Product change notification (PCN)

Title / short description	Design update and voltage rating enhancement for UDK 4-MTK* products
Affected article category	Terminal blocks
Change category	Form and appearance, Characteristics
Change number	CBE250090-00
Reason for PCN/PDN Revision

UDK 4-PE

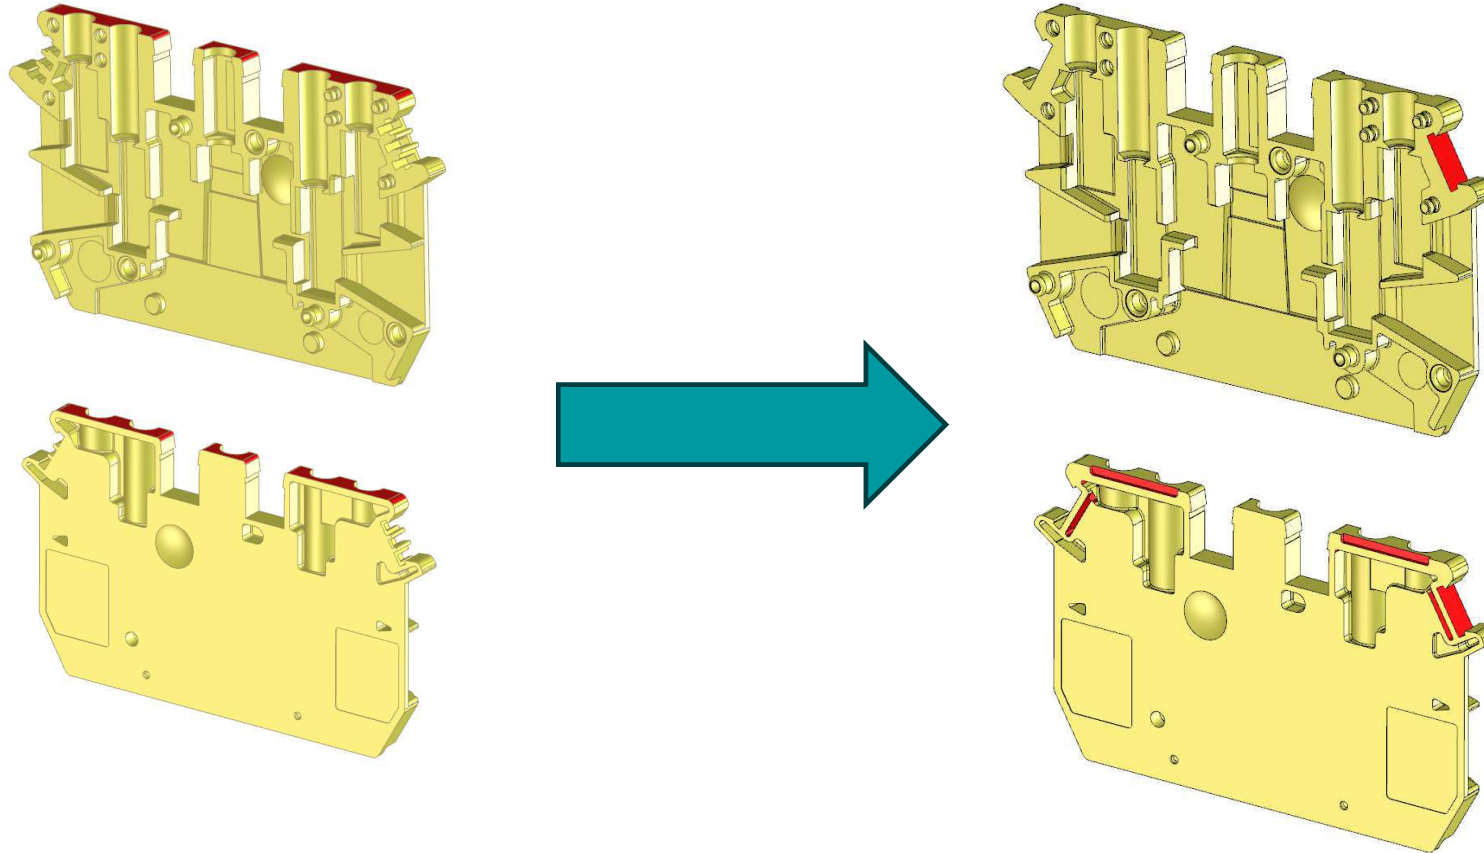
- Housing will be slightly adjusted to increase insulation distances, thereby allowing higher insulation voltages.
- Description fields on the housing will be updated to reflect the increased IEC nominal voltage, which will change from 630 V to 690 V.
- UL voltage ratings will be increased accordingly

Due to insulation-related design adjustments, the visual appearance of the housing will differ slightly from the previous version (see attachment).
